TOWN OF MOUNTAIN VILLAGE **DESIGN REVIEW BOARD REGULAR MEETING** THURSDAY MAY 4, 2017 10:00 AM 2nd FLOOR CONFERENCE ROOM, MOUNTAIN VILLAGE TOWN HALL 455 MOUNTAIN VILLAGE BLVD, MOUNTAIN VILLAGE, COLORADO **REVISED** AGENDA

Agenda Item # 5 PLANNING & DEVELOPMENT SERVICES DEPARTMENT PLANNING DIVISON 455 Mountain Village Blvd.

- TO: Design Review Board
- FROM: Dave Bangert, Senior Planner
- FOR: Meeting of May 4, 2017
- **DATE:** April 27, 2017
- **RE:** Consideration of a Design Review application for a new single-family dwelling on Lot 600BR-3, 19 Trails Edge Lane

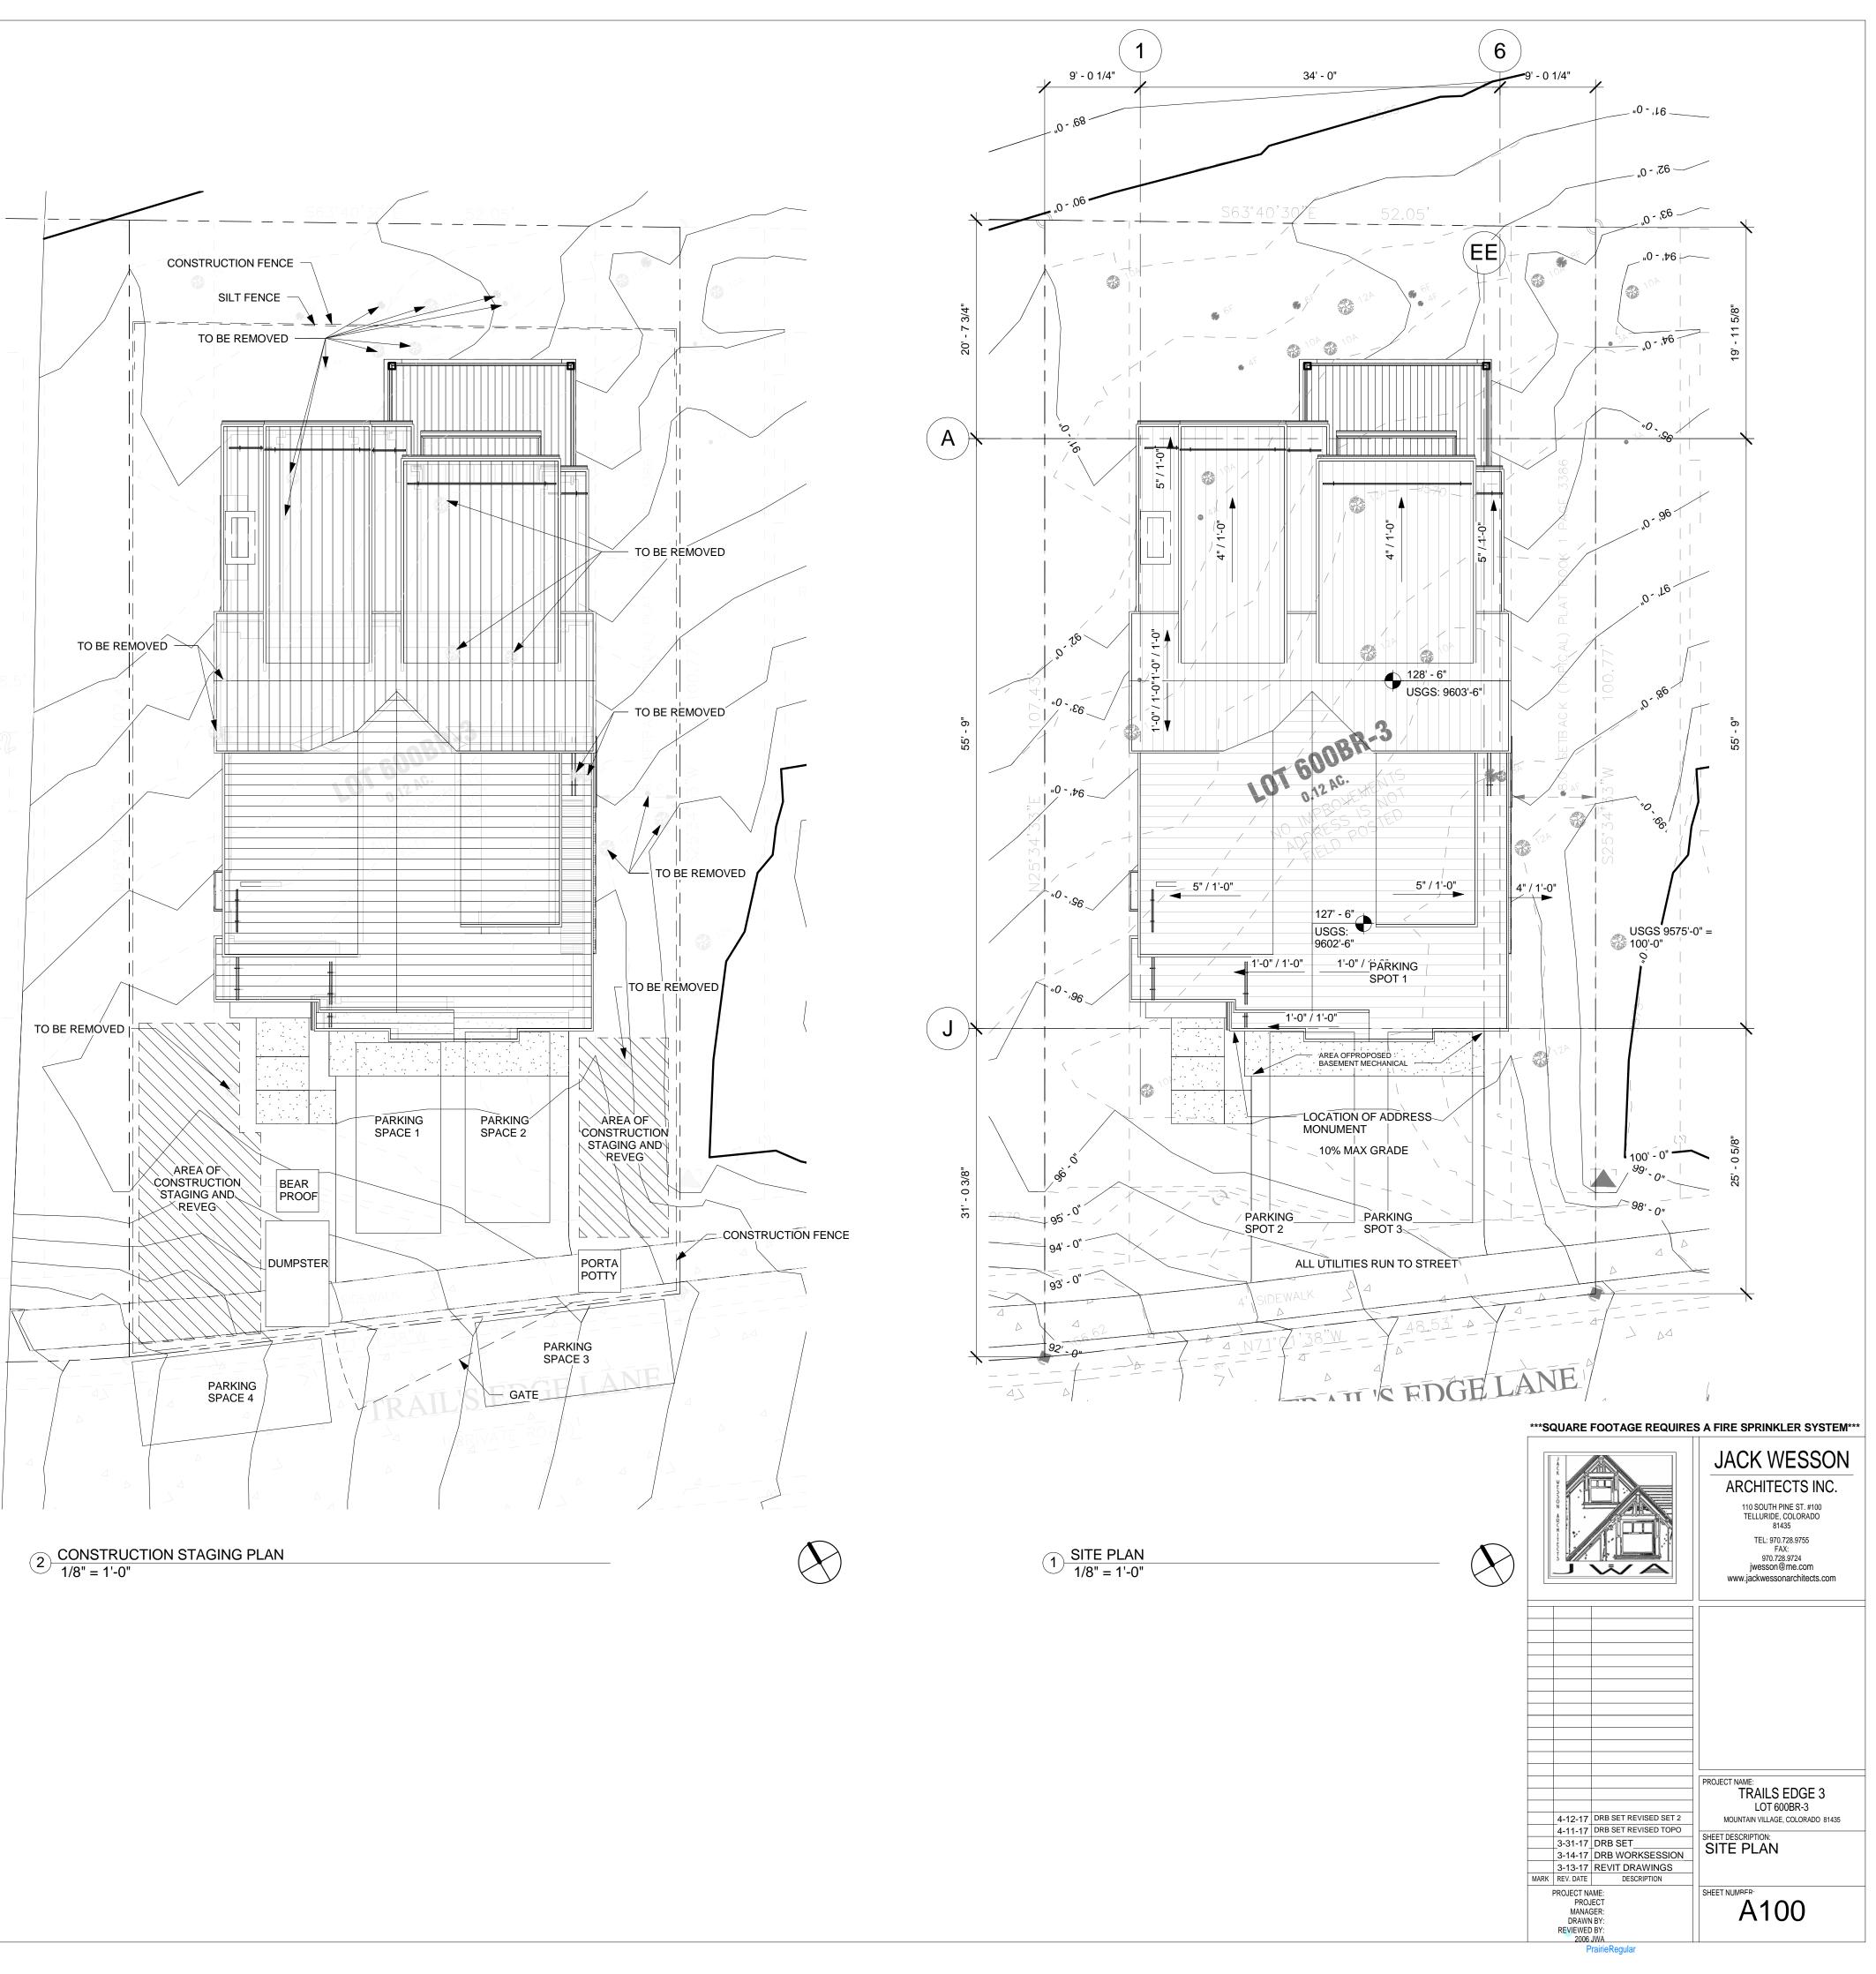
The layout and roof line of the unit is located completely within the allowable buildable area of the lot with no encroachments proposed. However, some disturbances, tree removal and construction staging is proposed within 8' Setbacks surrounding the buildable area. The DRB should review the site plan and determine whether the construction staging encroachments into the 8' Setbacks would cause unreasonable negative impacts to the surrounding properties. Because the foundation is less than 5' from the setbacks a monument survey of the footers will be required before the pouring of concrete. This will be a condition of approval.

All construction staging is proposed within the lot lines but will be in the east, west and south 8' setbacks. Additional construction parking is shown along Trail Edge.

- 1. A survey of the footers will be provided prior to pouring concrete to determine the encroachment into the east side setback will not exceed two feet and there are no encroachments into the west side eight foot setbacks.
- 2. The residence shall have a monitored fire sprinkler system; and the numbers on the address monument shall be coated or outlined with material to cause them to be reflective.
- 3. Prior to the issuance of a building permit, the applicant shall field verify all utilities and submit a revised utility plan to the public works director identifying the location of utilities and connection points."

TRAILS EDGE 2 LOT 600BR-2 MOUNTAIN VILLAGE, COLORADO 81435 SHEET DESCRIPTION: LANDSCAPE PLAN

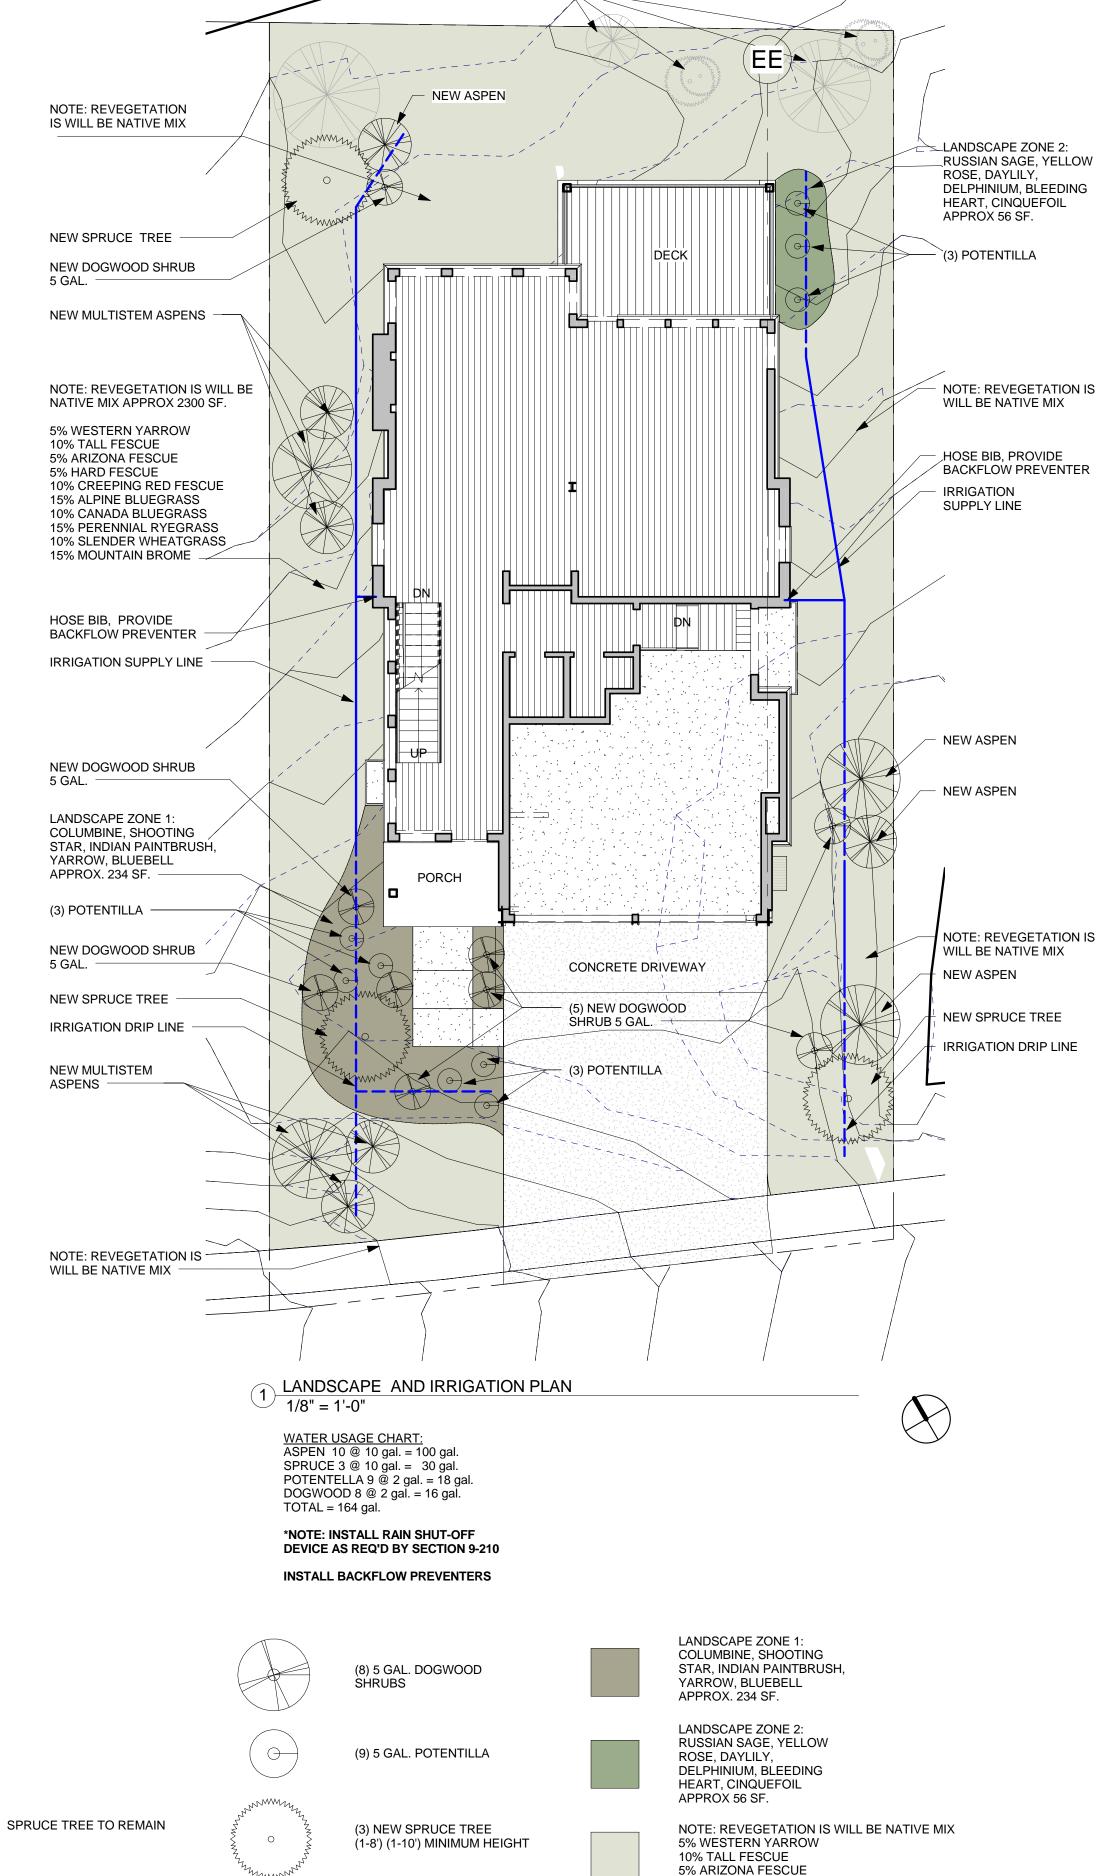
The proposed landscape plan shows eleven (11) aspens and three (3) spruces to be planted, in additions to nine potentilla shrubs. All plantings shall be in compliance with Table 5-4 of the CDC:
